CONSULTEE RESPONSE (Council's Arboriculturist)

Reference: AW/104/26/T

Location: 17 Margaret Close, Aldwick, PO21 3AA

Proposal: Crown reduction to 1no. lime to previous pollard points, leaving 0m spread. Crown lift to 1no. maple to 4m from ground level, crown reduction to leave an easterly spread of 3m. Remove overhanging limb over garden room on 1no. ash.

Figure 2 Positions of final cuts

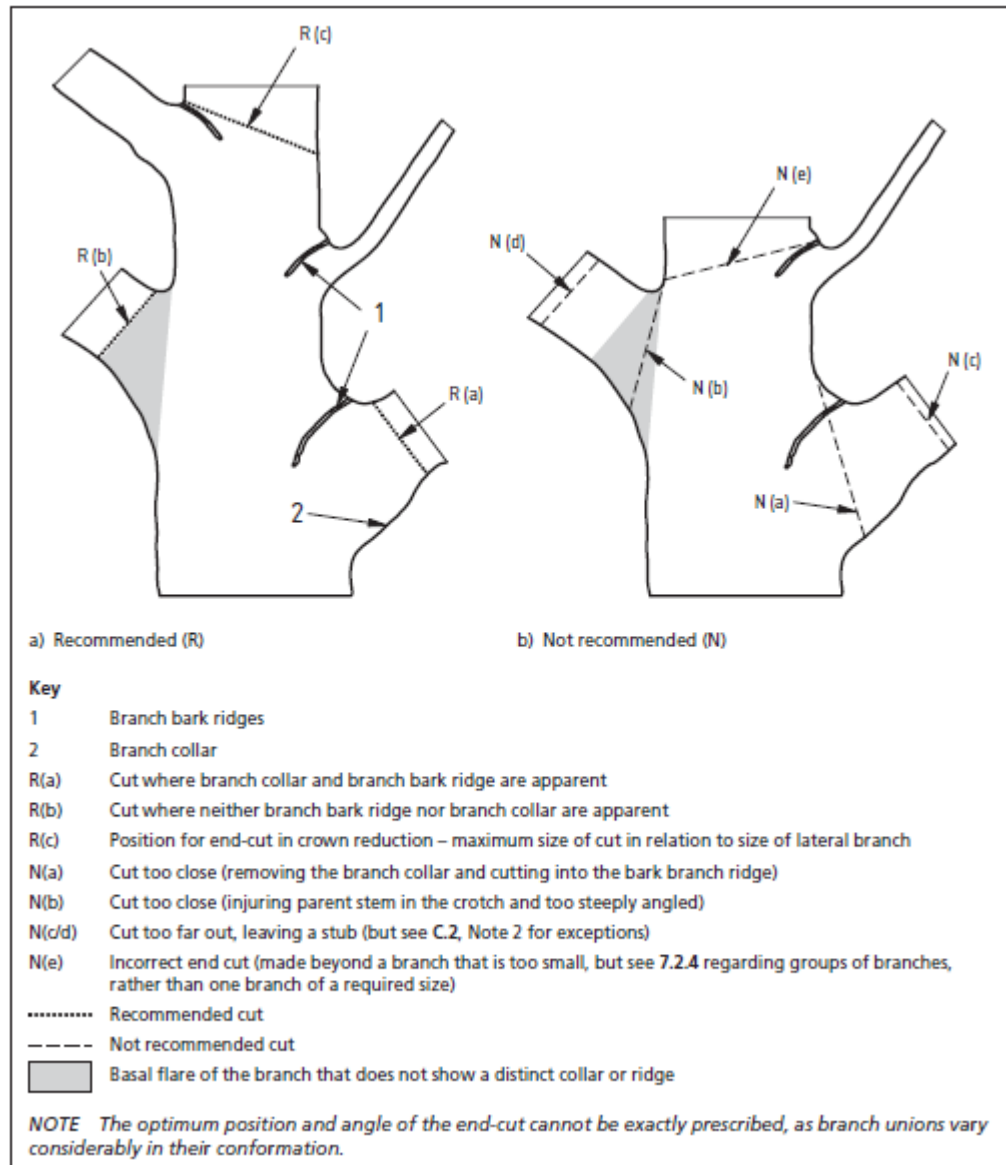
Part a) Where whole branches are to be removed and final cuts made close to the trunk or branch union they are to be made as shown in Figure 2 of BS3998:2010
